Well Name: GOVT NBFD	Well Location: T20S / R28E / SEC 11 / SWSW / 32.5827522 / -104.1555346	County or Parish/State: EDDY / NM
Well Number: 1	Type of Well: CONVENTIONAL GAS WELL	Allottee or Tribe Name:
Lease Number: NMNM15003	Unit or CA Name:	Unit or CA Number:
US Well Number: 300152884100D1	Operator: PERMIAN RESOURCES OPERATING LLC

Type of Action: Plug and Abandonment

P&A Proposed NOI
Permian Resources Operating LLC
Government NBFD #1
30-015-28841

REVISED

Proposed WBD	
Author:	Shyanne @ JMR
Well Name	Government NBFD
Field/Pool	Flat Wolfcamp/North Burton Flat N
County	Eddy
State	NM
Spud Date

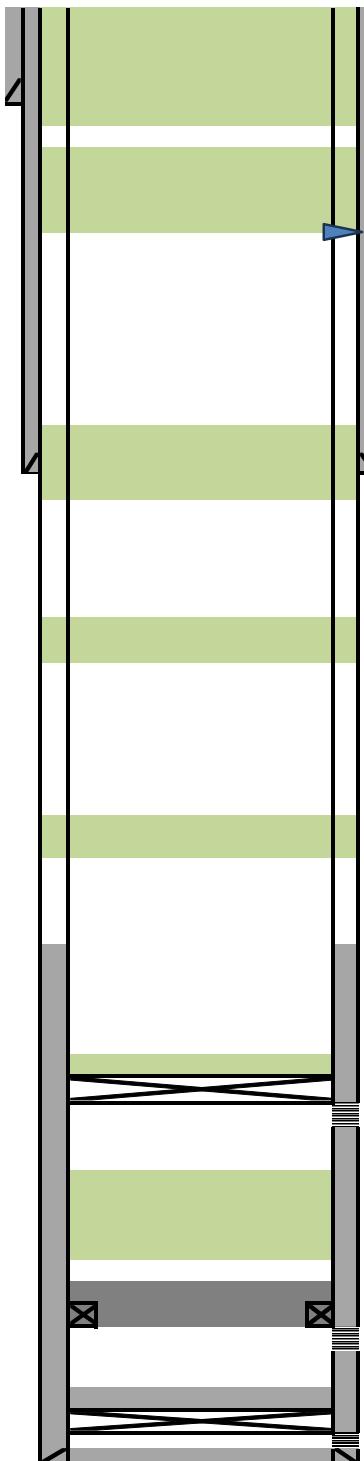
14. CBL on file TOC 5.5" 7500'. **Send CBL to BLM.**
15. Trip in hole and tag CIBP @ ~9072'
16. Plug #2: (Wolfcamp) Spot **25** sxs class H cmt from 9072' to **8939'**.

17. Plug #3: (Spacer) Sqz 42 sxs (**17** in/26out) class C cmt w/2% CaCl from 7000' to **6830'**. WOC 4hrs. & Tag.
18. Plug #4: (Bone Springs) Sqz 42 sxs (16 in/26out) class C cmt w/2% CaCl from 4971' to **4821'**. WOC 4hrs. & Tag.

19. Plug #5: (Delaware/Inter Shoe) Sqz 90 sxs(30in/60out) class C cmt w/2% CaCl from 3180' to **2920'**. WOC 4hrs & Tag.
20. Plug #7: (Surf Shoe/Surface) Circulate **249** sxs (**111in/138out**) class C cmt from **1022'** to 0'. Verify and Bubble test.

Proposed WBD	Shyanne @ JMR
Author:	Shyanne @ JMR
Well Name	Government NBFD
Field/Pool	Flat Wolfcamp/North Burton Flat N
County	Eddy
State	NM
Spud Date

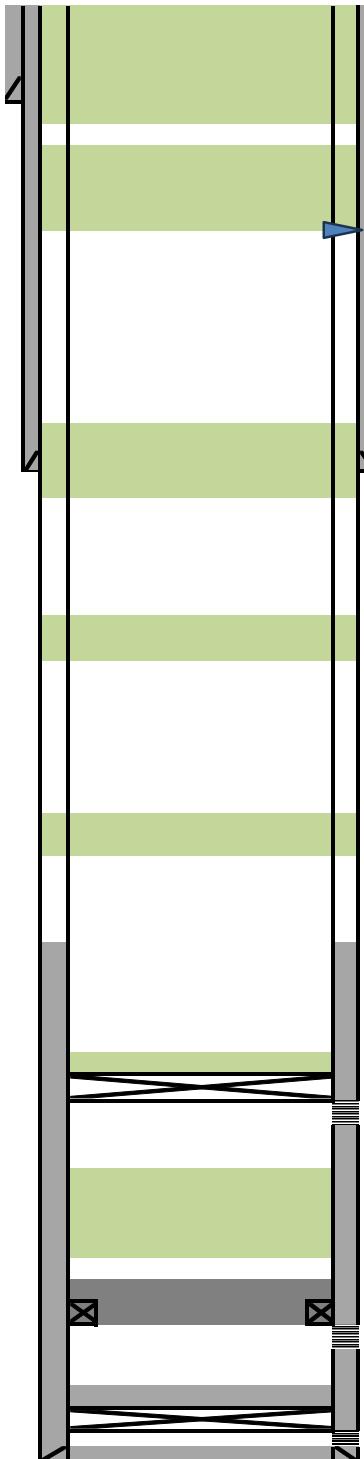
Plug Type	Top	Bottom	Length	Tag	Sacks	Cement Class	Notes
Surface Plug	0.00	100.00	100.00	Tag/Verify			
13.375 inch- Shoe Plug	346.00	450.00	104.00	Tag/Verify			
Base of Salt @ 609	552.91	659.00	106.09	Tag/Verify			
Yates @ 972	912.28	1022.00	109.72	If solid base no need to Tag (CIBP present and/or Mechanic al Integrity Test), If Perf & Sqz then Tag, Leak Test all CIBP if no Open Perforatio ns	249.00	C	Perf and circulate from 1022' to surface.

8.625 inch- Shoe Plug	2920.00	3050.00	130.00	Tag/Verify			
Delaware @ 3130	3048.70	3180.00	131.30	If solid base no need to Tag (CIBP present and/or Mechanic al Integrity Test), If Perf & Sqz then Tag, Leak Test all CIBP if no Open Perforatio ns	61.00	C	Perf and squeeze from 3180' to 2920'. WOC and Tag. (In 26 sxs/Out 35 sxs)
Bonesprings @ 4921	4821.79	4971.00	149.21	If solid base no need to Tag (CIBP present and/or Mechanic al Integrity Test), If Perf & Sqz then Tag, Leak Test all CIBP if no Open Perforatio ns	35.00	C	Perf and squeeze from 4971' to 4821'. WOC and Tag. (In 15 sxs/Out 20 sxs)

Spacer Plug @ 6950	6830.50	7000.00	169.50	If solid base no need to Tag (CIBP present and/or Mechanic al Integrity Test), If Perf & Sqz then Tag, Leak Test all CIBP if no Open Perforatio ns	40.00	C	Perf and squeeze from 7000' to 6830'. WOC and Tag. (In 17 sxs/Out 23 sxs)
Wolfcamp @ 9080	8939.20	9130.00	190.80	base no need to Tag			
CIBP Plug	9037.00	9072.00	35.00	If solid base no need to Tag (CIBP present and/or Mechanic al Integrity Test), If Perf & Sqz then Tag, Leak Test all CIBP if no Open Perforatio ns	25.00	H	Set CIBP at 9072'. Leak test CIBP. Spot cement from 9072' to 8939'.
Perforations Plug (If No CIBP)	9072.00	9276.00	204.00	Tag/Verify			
Strawn @ 10072	9921.28	10122.00	200.72	If solid			
Atoka @ 10394	10240.06	10444.00	203.94	If solid			
Morrow @ 10617	10460.83	10667.00	206.17	If solid base no need to Tag (CIBP present and/or Mechanic al Integrity Test), If Perf & Sqz then Tag, Leak Test all CIBP if no Open Perforatio ns	107.00	H	Spot cement from 10667' to 9805'. WOC and Tag.
